Authorized Field Change

AFC G-05902 Revised

Subject: 3200, 4000, 7000, and 8000 HPV Models Built Between March 01, 2004 and January 22, 2005 with an International I313 Engine and Feature Code 15LJM, Heater Fuel / Water Separator, will Require an Overlay Harness to make Code 15LJM Fully Functional

Figure 1 Heater Fuel/ Water Separator Connector (Arrow)

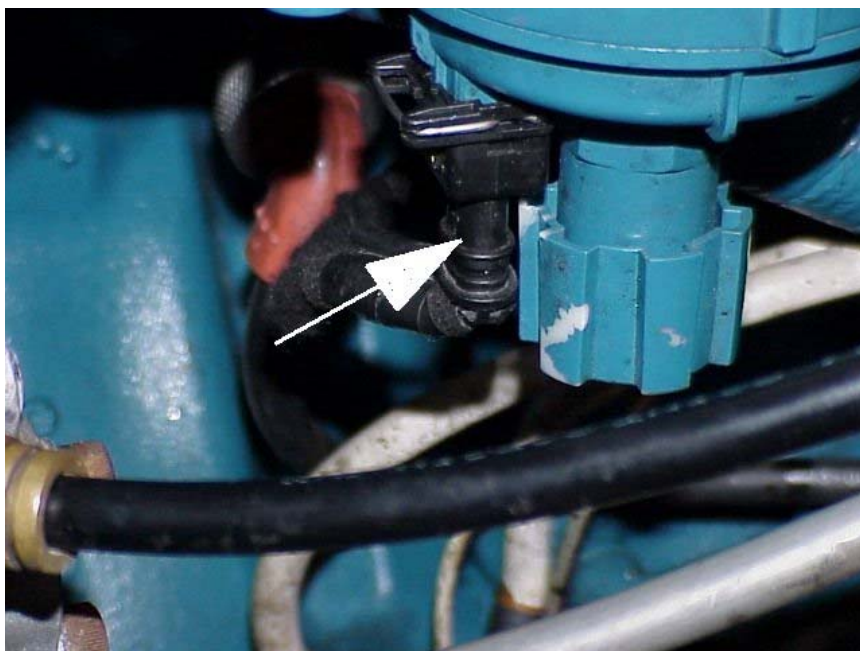
1. Disconnect the battery negative cable.
2. Disconnect the harness connector from the heater fuel/ water separator (Figure 1).

Figure 2 Overlay Harness

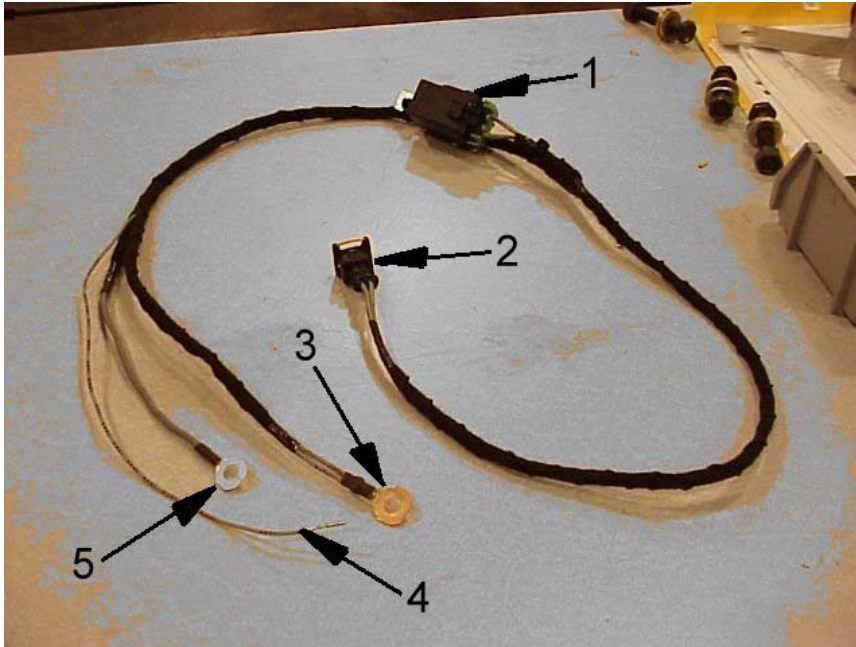
3. Fold over the removed connector and wire lead and tape securely.
4. Refer to Figure 2 and Figure 3 to identify overlay harness leads. Install the ground, white wire, eyelet to the cab ground stud (Figure 4).

1. Relay
2. Connector (To Heater Fuel/ Water Separator)
3. White Wire Eyelet (To Cab Ground Stud)
4. Pink Wire Lead (To ESC Connector)
5. Grey Wire Eyelet (To Mega Fuse)

Figure 5 Connect to Non Fused Side of Mega Fuse

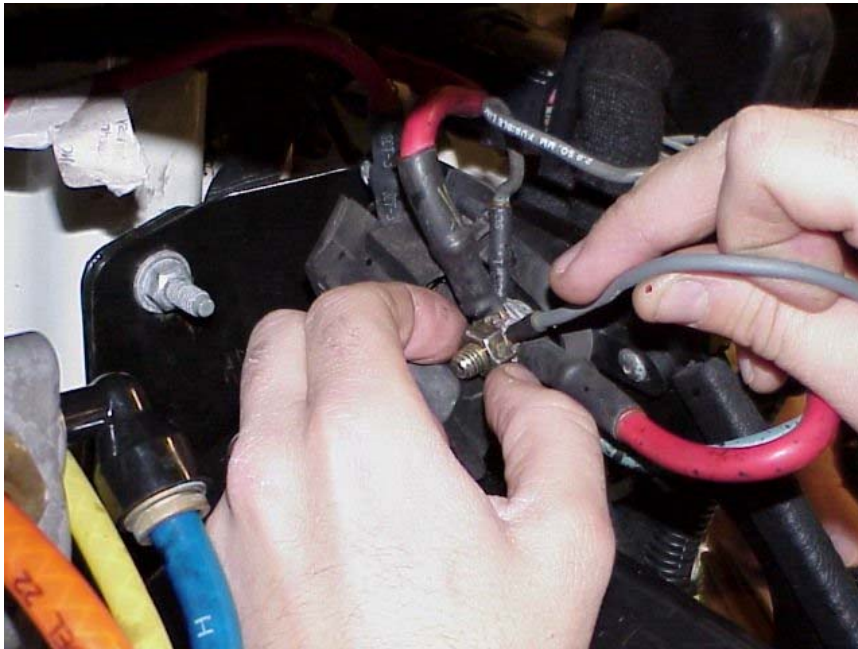
5. Refer to Figure 2 and identify overlay harness, grey wire (labeled fusible link), power eyelet connector. Install the power eyelet to the non-fused side (forward stud terminal) of the mega fuse (Figure 5).

Figure 6 Remove ESC Connector (Arrow)

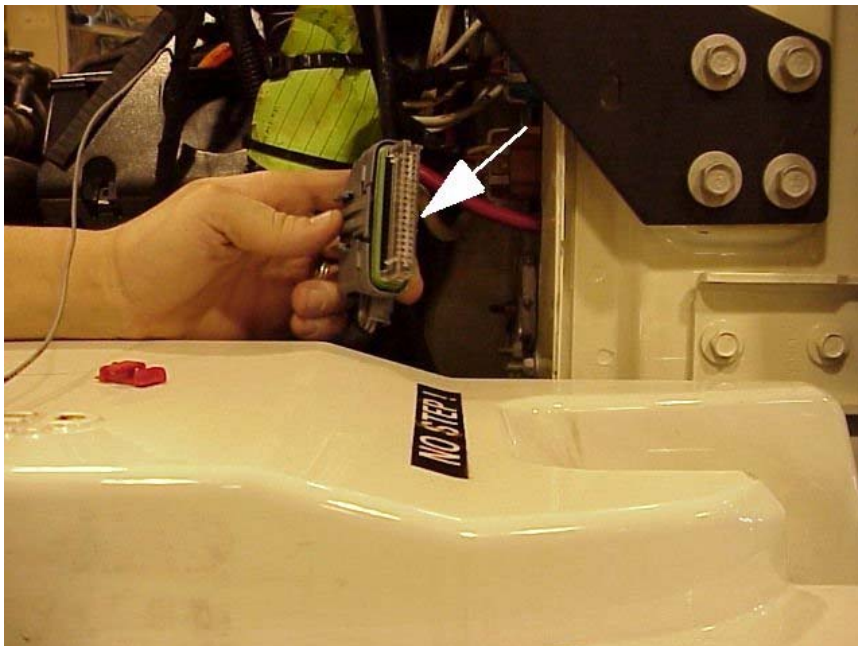
6. Locate and remove the ESC connector 4004 (Figure 6).

Figure 7 Insert Overlay Harness Wire Into Connector

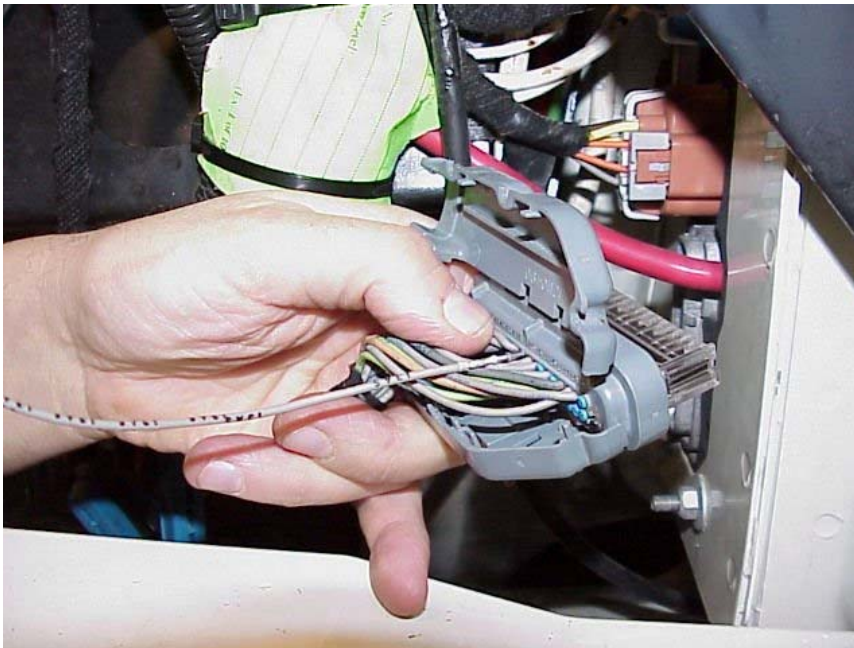
7. Refer to Figure 2 and Figure 7 for the following:

- **Vehicles with Hydraulic Brakes:** Insert the pink overlay harness wire into ESC connector position 32 and reinstall connector 4004 into the ESC.
- **Vehicles with Air Brakes:** Insert the pink wire into ESC connector position 28 and reinstall connector 4004 into the ESC

Figure 8 Connect Overlay harness Connector to Heater Fuel / Water Separator

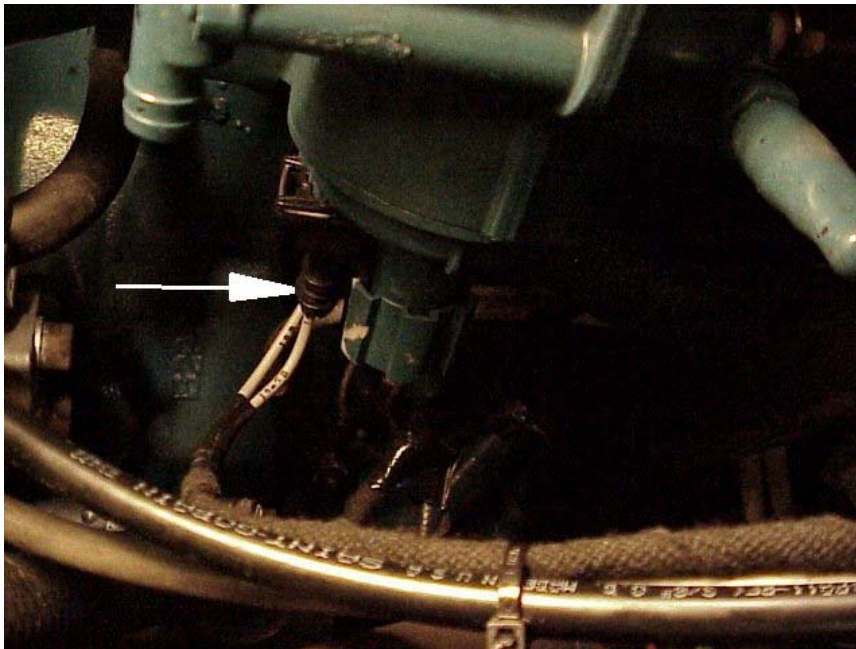
8. Connect the overlay harness connector (Figure 2, Item 1) to the heater fuel/ water separator (Figure 8).
